Sutherland Local Access Forum

25th March 2024

Proposed Core Path Diversion – Upper Bighouse SU19.03

Appendix A – Core path purple. Proposed Diversion Red

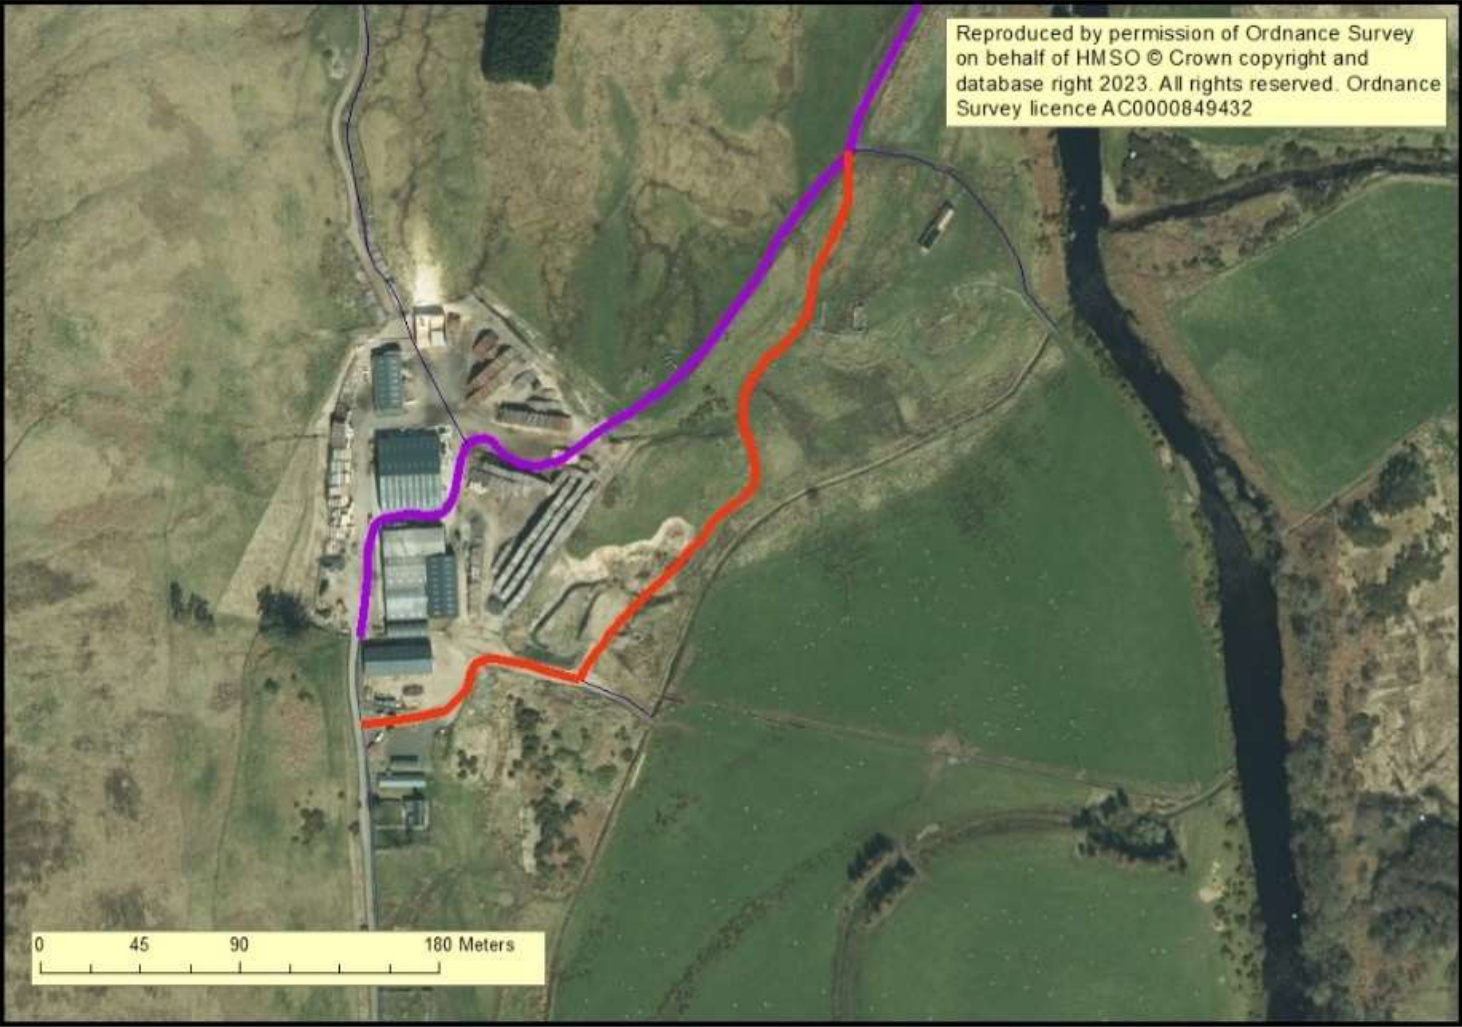
The Access Officer visited the site with the owner and walked the proposed route shown in Appendix A.

Subject to the completion of quarry operations close to the start of the new line, improvement to the walking surface in the northern section and upgrade of existing field gates/new pedestrian gate(s) throughout; the initial walk over the Council Access Officer was of a positive benefit to realigning the core path at Upper Bighouse.

- 1- Realigned route is approx. 35m longer (360m – original vs. 395m realigned). Unlikely significant on its own but when considering whole route through to Kirkton is 4.6km then diversion is insignificant.

- 2- Existing route is a mix of built track and desire line over grassed fields, in places very little evident path surfacing – occasional wheel ruts. As such there is no clear width to the existing path and the surface is anything from aggregate to grass. The realigned path will be similar with a mix of built path and path formed through use. Any path formation should be to 1.5m. If required aggregate will be used on soft ground encountered. There are no drainage features on the existing route.

- 3- Amenity and enjoyment of the route will be enhanced by taking the public away from the industrial nature of Upper Bighouse.
- 4- The New line does drop and rise as it skirts Upper Bighouse, less than 10m. This will be mitigated by the formation of a path as the path rises from the old quarry, benched across the slope. Increase in amenity more than makes up for in short descent and ascent. Route through to Kirkton gains height at the bealach (50m) for the whole route is not flat.

- 5- As for amenity in 3- the old line poses HSE management consideration for the owner which are not applicable to the new route. The realigned route is with the same ownership.

- 6- Owner has stated works will be completed by them. Council has offered to waymark in order to maintain consistent design across other core paths in Highland, also offered a gate in place of existing double leaf field gate (with throw over loop) which is LRA compliant but not public friendly.

The Local Access Forum is being asked to consider two questions;

- **Does the forum support the proposed diversion?**
- **Is the alternative route a significant change or a *de minimis* (very minor alteration) that can be accessed at senior officer level?**
